Guidance for Conducting Technical Analyses for Low-Level Radioactive Waste Disposal

**Subject: Comments to Proposed Rule and Part 61 Guidance, Low-Level
Radioactive Waste Disposal, 80 FR 16082 and 80 FR 15930**

COMMENTS ON THE PROPOSED REVISIONS TO 10 CFR PART 61

COMMENTS ON NUREG-2175, GUIDANCE FOR CONDUCTING TECHNICAL ANALYSES FOR 10 CFR PART 61

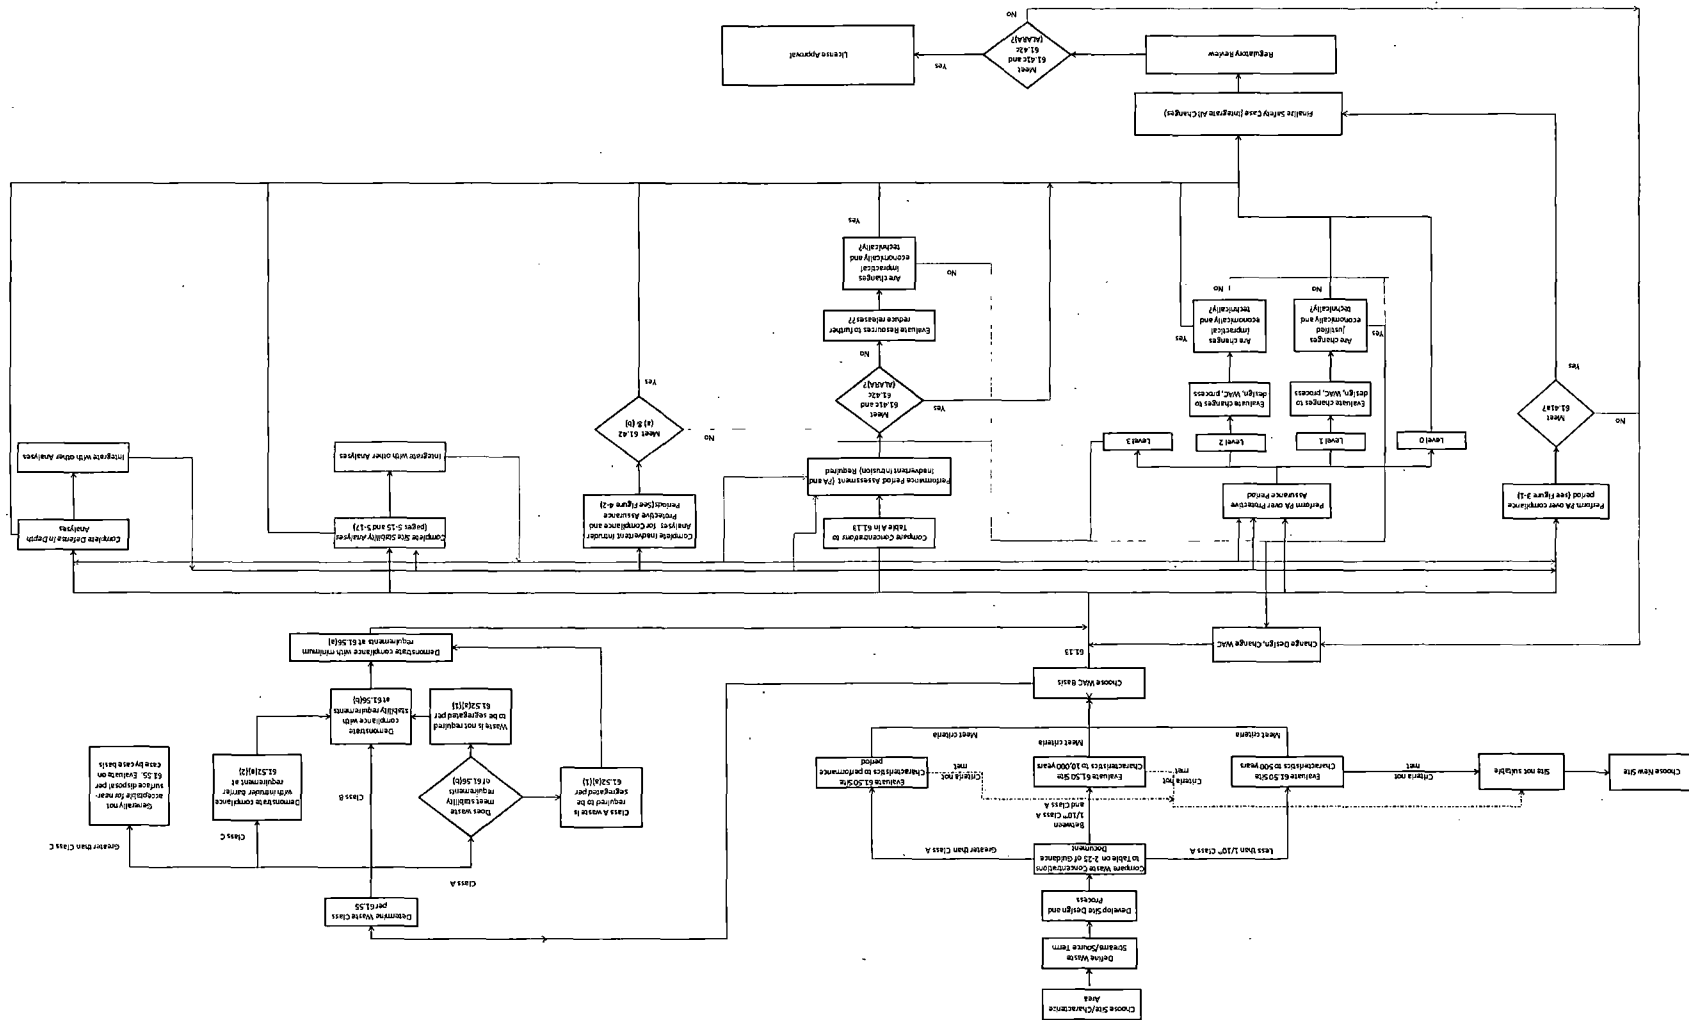
We attempted to create a flowchart to fit the pieces of the proposed rule together (see Figure 1). This flowchart clearly illustrates the cumbersome nature of the process. We recommend several changes that should streamline the process, including using a two-tier system. These are discussed in further detail in the following sections.

Recommendation – We propose that the NRC include a flowchart of the process so that an applicant or licensee can understand the components, requirements, key decision points, and how they fit together.
